**RE: Harper Senior Living
Grading and Drainage Plan
Engineer's Stamp Date: 02/01/19
Hydrology File: E20D020B**

Re: Harper Senior Living, E20D020B Hydrology Site Plan for Building Permit Approval

Enclosed for your review is a copy of the Harper Senior Living Grading and Drainage Resubmittal. Below is a brief description of how the comments from your letter dated 12/13/18 were addressed:

C-100

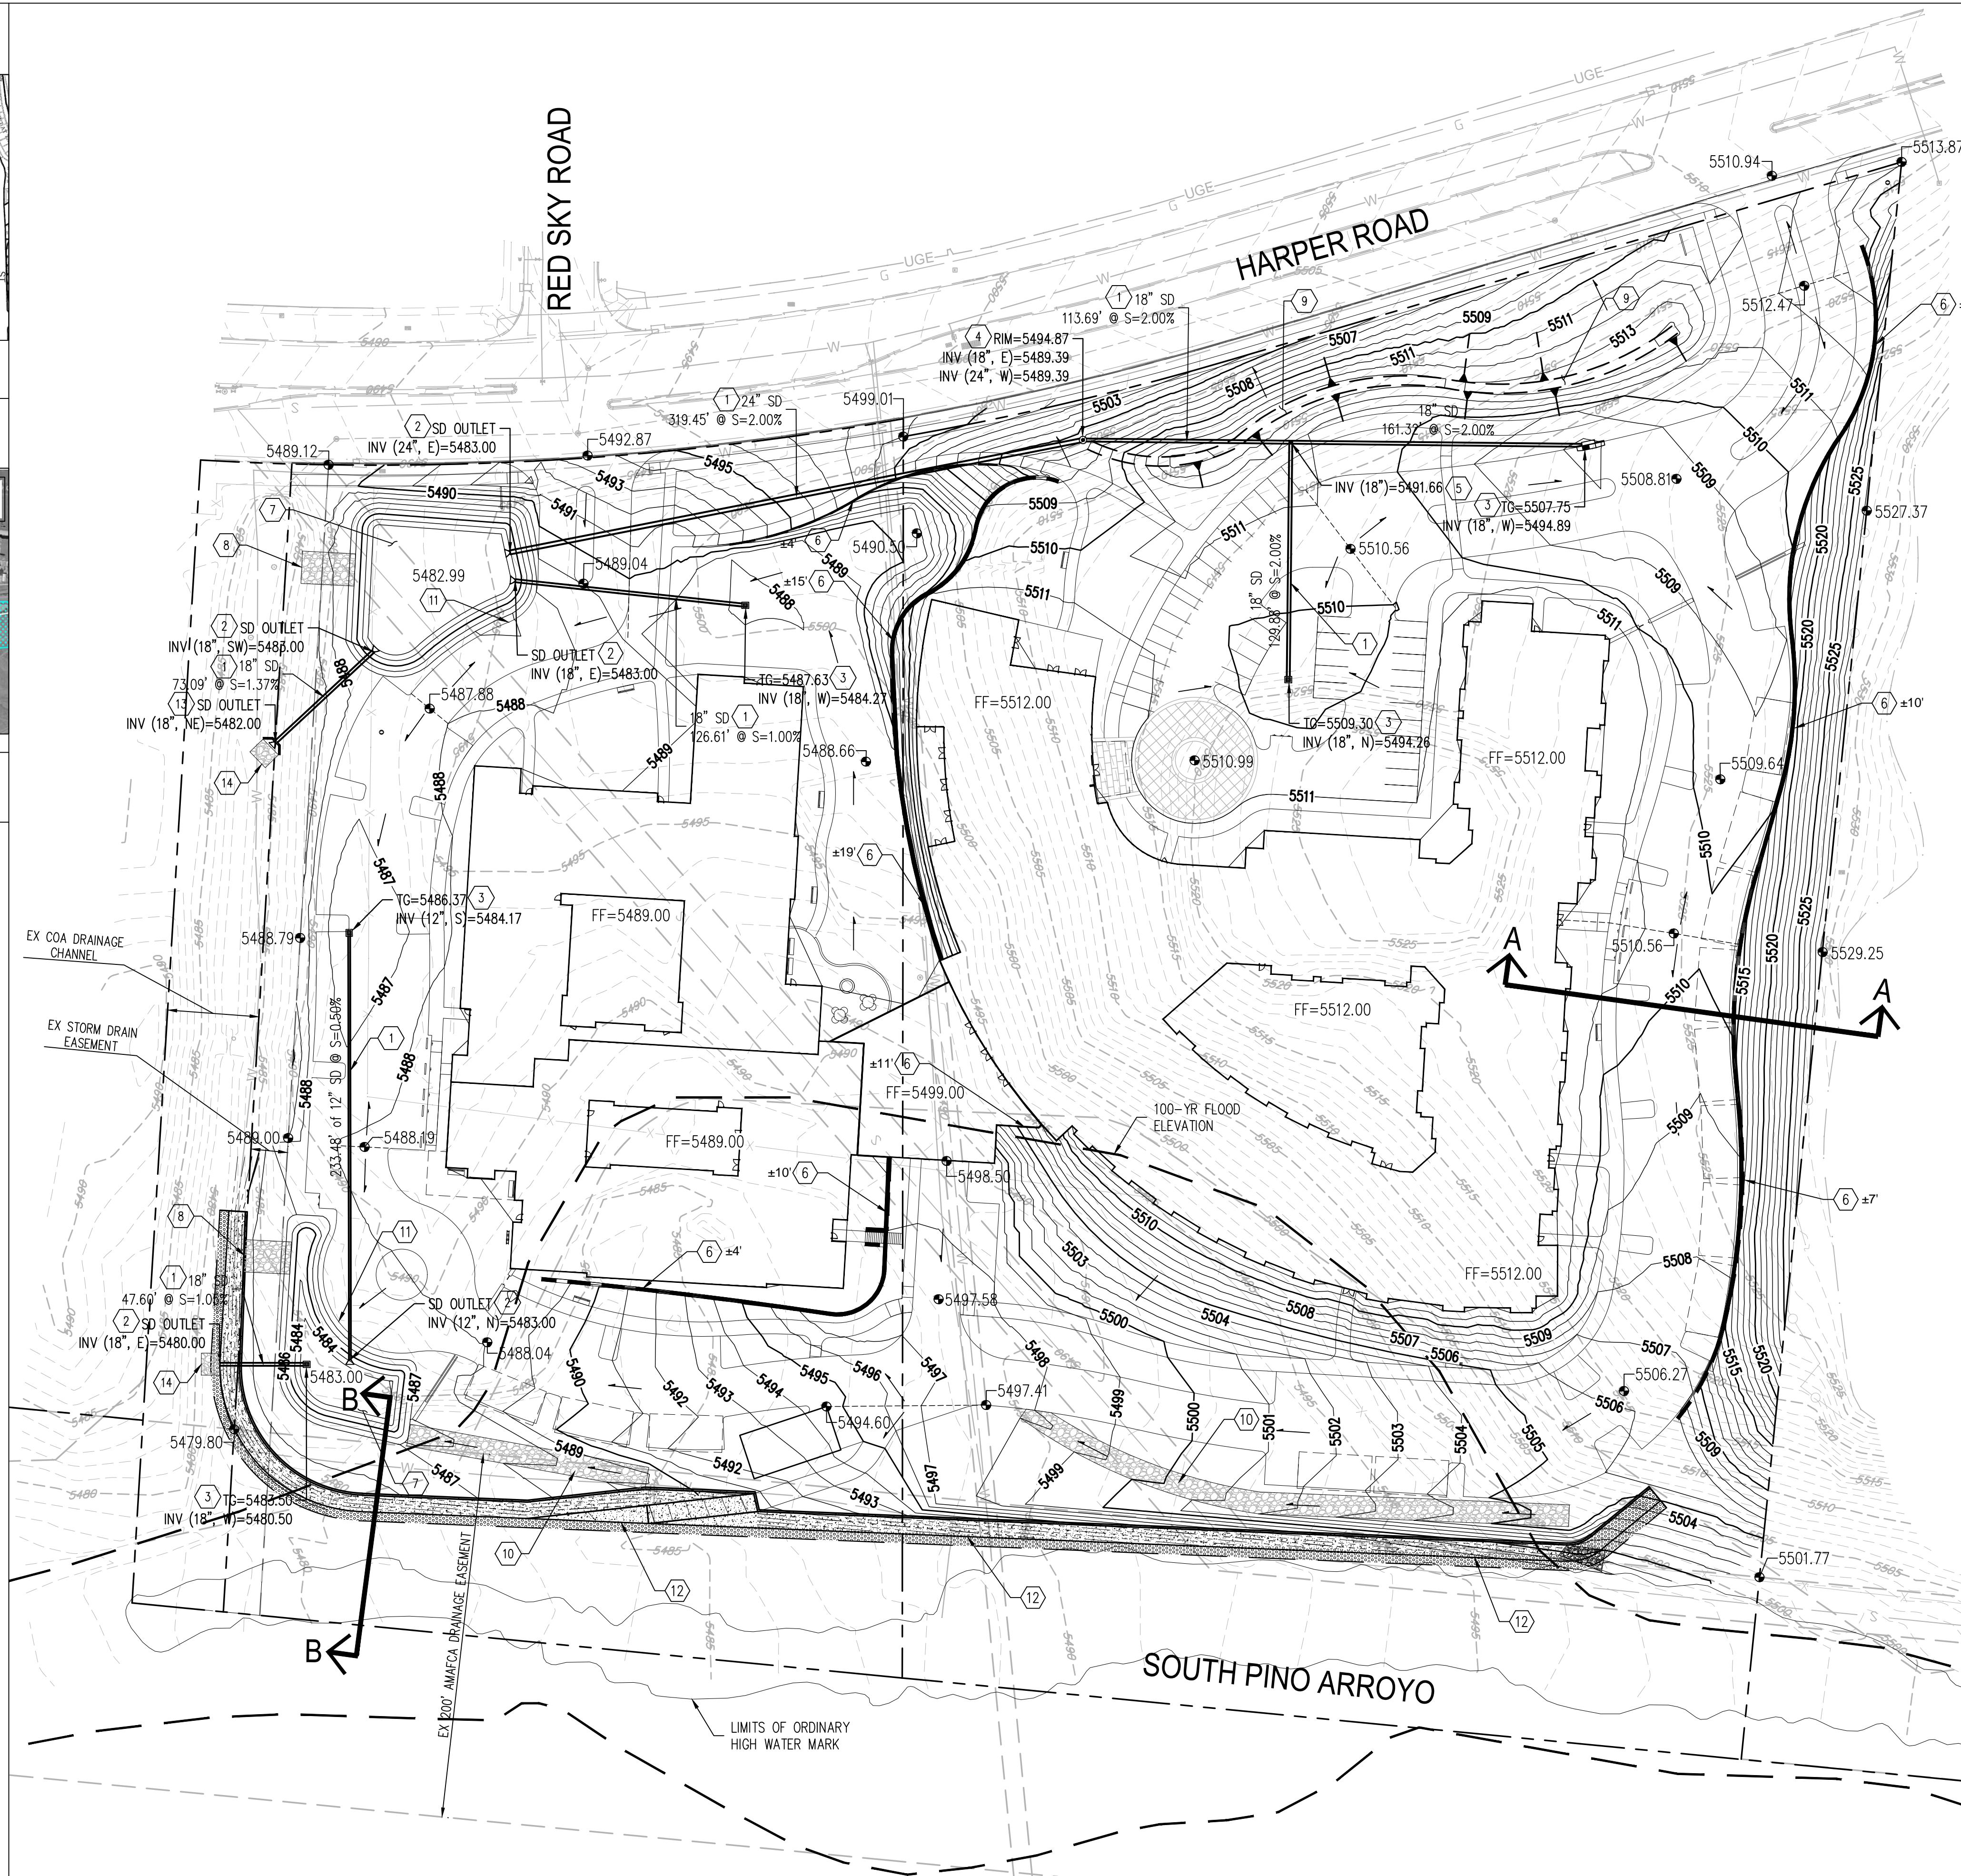
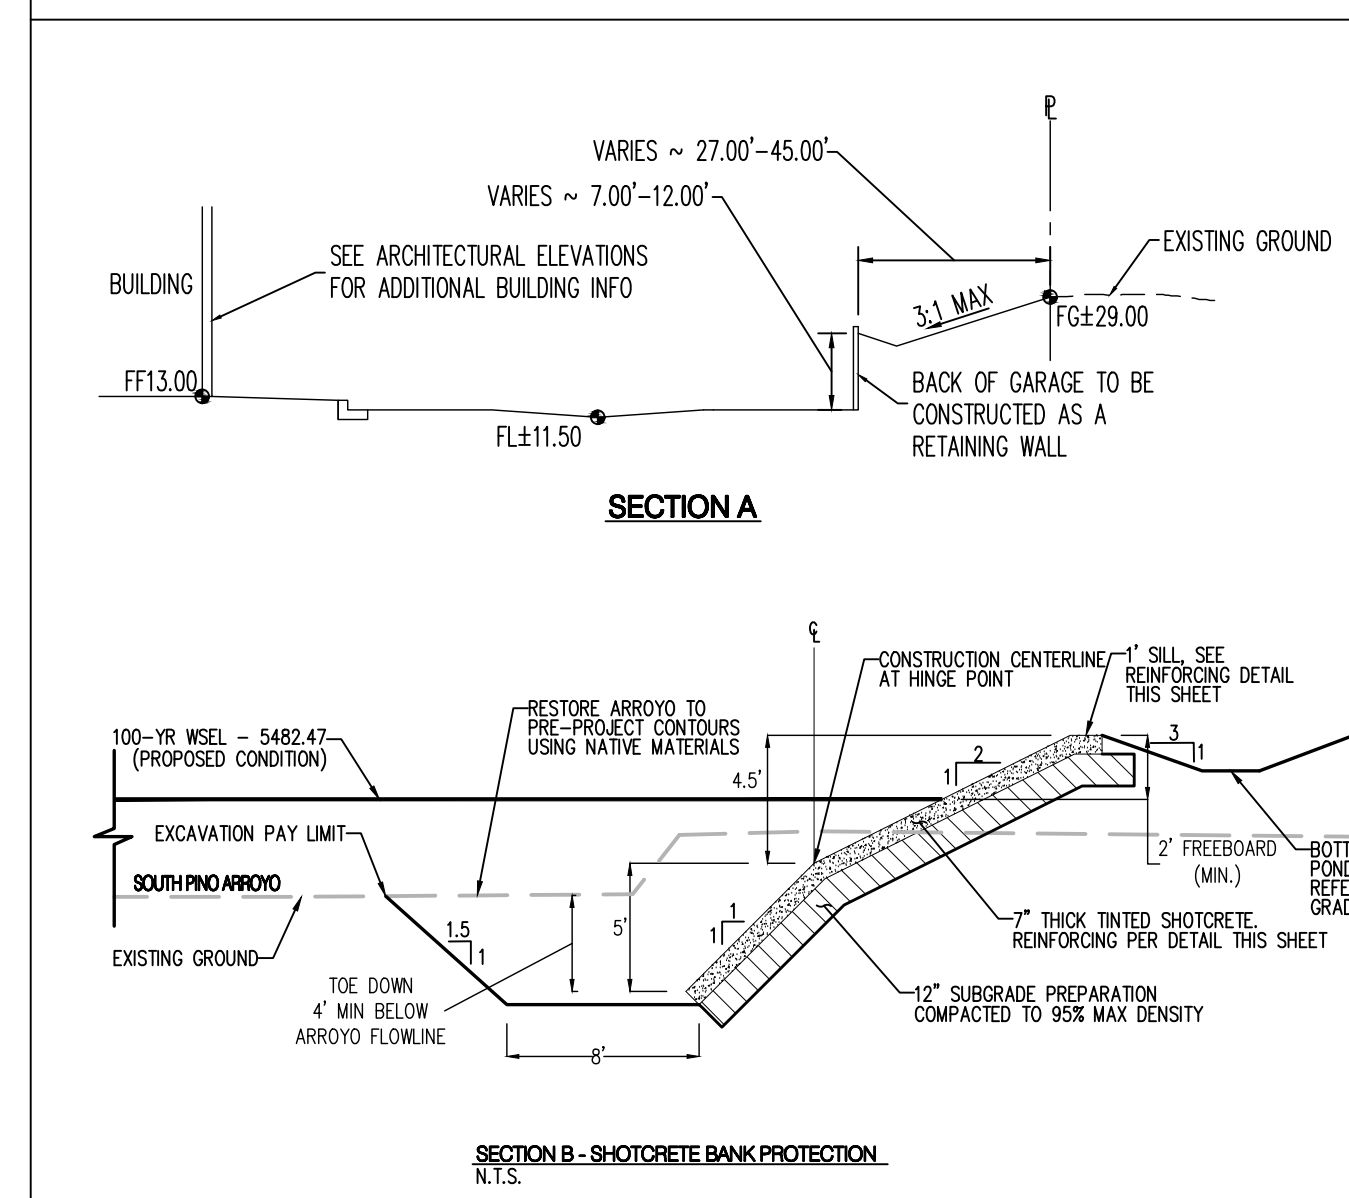
1. FIRM Map has been added to sheet C-100.
2. Vicinity Map has been added to sheet C-100.
3. Legal Description has been added to sheet C-100.
4. Benchmark Information has been added to sheet C-100.

5. The 100 Year Flood Zone Line per your comment is now shown and is more legible. The "Floodplain Easement" roughly follows the limits of this flood zone.

6. The Existing Contour Labels have been adjusted to be more legible.
7. A retaining wall is now shown along the sidewalk as noted.
8. A headwall will be installed to allow us to pull the storm drain end section further from the ditch's flow line. Riprap is now provided at this outfall location for energy dissipation as well.

9. The Bank Stabilization has been wrapped around the SW corner of the site per COA's request.
10. Concrete lining the bottom of the Pond 1 seems unnecessary. Concrete lining eliminates storm water harvesting as a portion of this pond was intended to be used for. An emergency riprap lined overflow is located along the west side of the pond. In the event of an emergency, this pond will discharge to the COA's ditch and the bank stabilization will be designed to accommodate this overflow.

11. The pipe now discharges through the concrete bank stabilization. This pipe will be mitered to the slope of the bank stabilization. A riprap energy dissipater is now located at the outfall location.

12. Runoff within Basin 1 will flow to the south then west within the drive aisle. We have now shown the location of a highpoint that will prevent any runoff from entering the AMAFCA access road. Any runoff that falls south of the drive aisle will enter a riprap

swale that discharges into the drive aisle near the AMAFCA access road. Detailed grading during the building permit phase of the project will refine this area and basins minimally.
